Changes from Rev E:

ReFlex Hand Controller			
Title	Number	Revision	F
Size	C		
Date:	2020-05-14	Sheet of	1
File:	C:\Users\reflex.brainboard\Reflex\HandController\ReFlex_Hand_Controller_V1.0	Drawn by:	Gabrielle Merritt
Open Source Robotics Foundation

## Ethernet

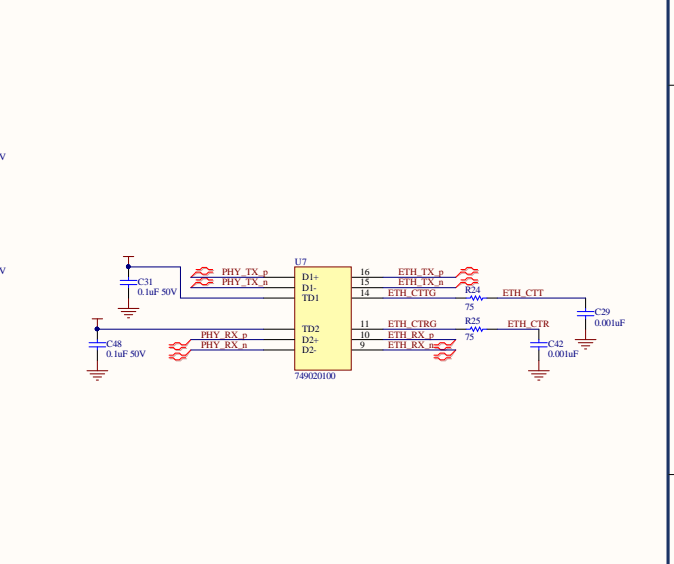
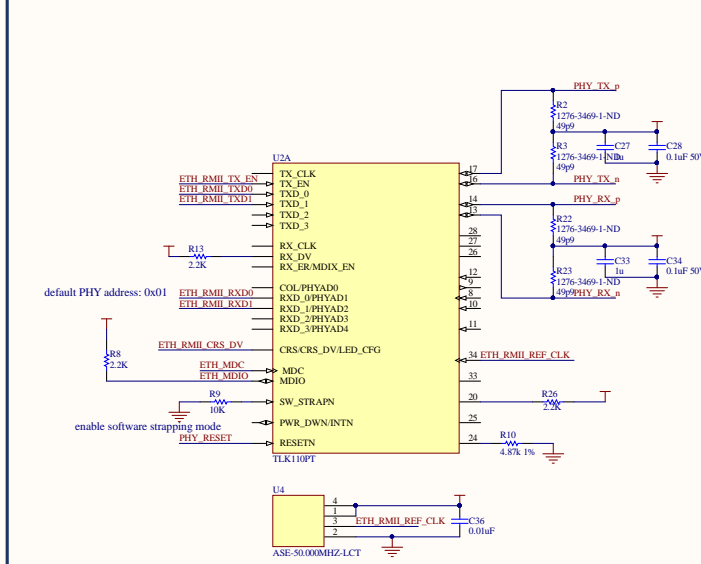
- \* Corrected pinout problem on Ethernet RX lines
- \* Changed T2 and T3 to alternate part due to assembly issues
- \* Changed J15 to SMT testpoints instead
